**Economic Commission for Europe****Inland Transport Committee****World Forum for Harmonization of Vehicle Regulations****Working Party on Lighting and Light Signalling (GRE)****Sixty-Ninth session**

**Regulations Nos. 3, 4, 6, 7, 19, 23, 38, 65, 69,  
70, 77, 87, 91, 98, 112, 113, and 119****Proposal for Supplement 3 to the 01 series of amendments to  
Regulation No. 113 (Headlamps emitting a symmetrical  
passing beam or a driving beam or both and equipped with  
filament lamps, gas-discharge light sources or led modules)****Submitted by the expert from Germany\***

The text reproduced below was prepared by the expert from Germany updating the Conformity of Production (CoP) requirements. The modifications to the current text of the UN Regulation are marked in bold for new or strikethrough for deleted characters.

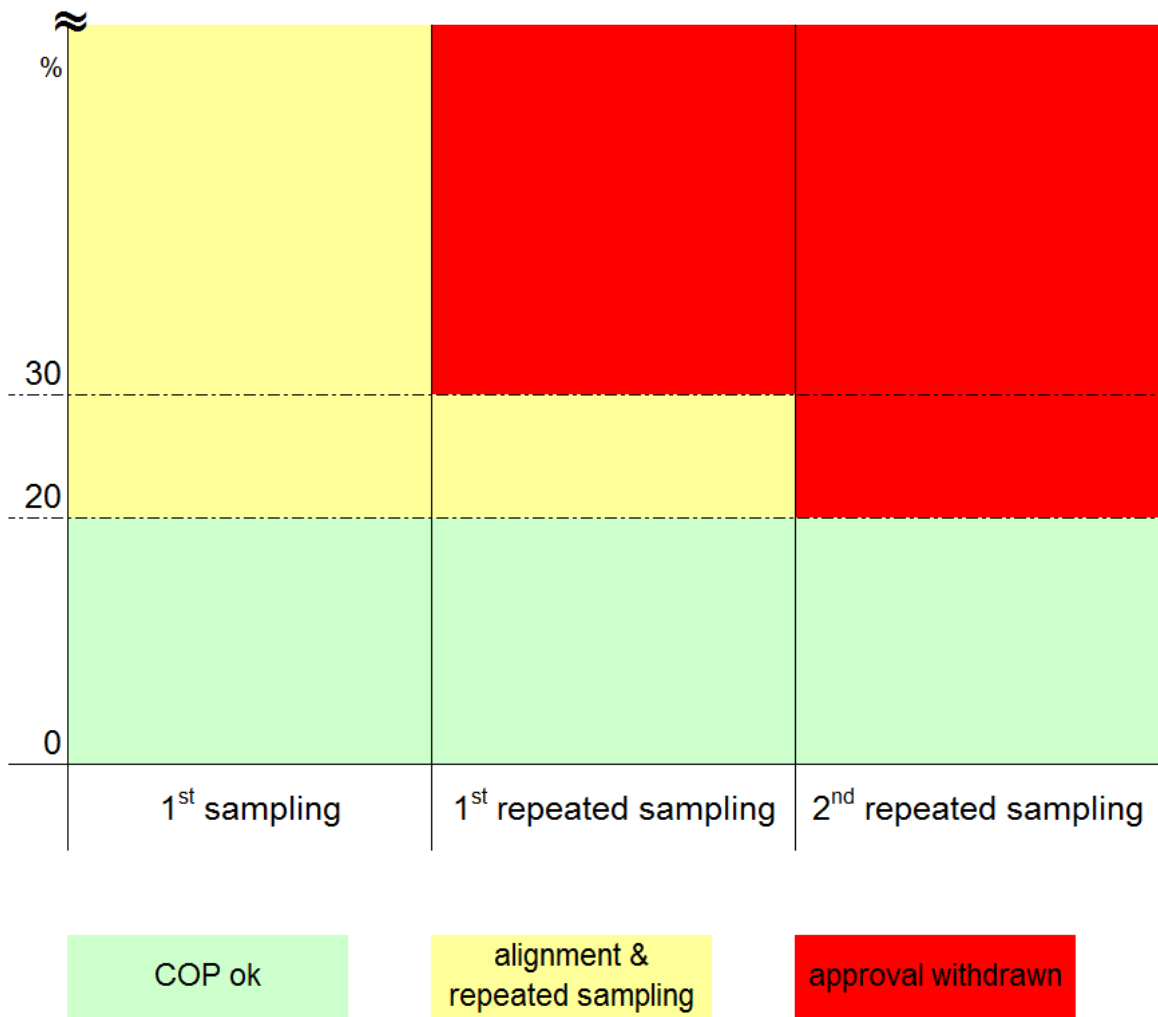
6. CoP is now described in a clear structured stepwise process (with limited steps), which gives the manufacturer the chance in the first step - in the case of deviations of more than 20 per cent - to align his production process. Also, the CoP process can be completed earlier when the first two samples are in the full specifications.

7. The proposal details the "third step" which defines the condition where the approval shall be withdrawn, when after the second repetition of this process the manufacturer was not in the position to "align" his production process in the correct way.

8. The attached drawing shall demonstrate this stepwise process.
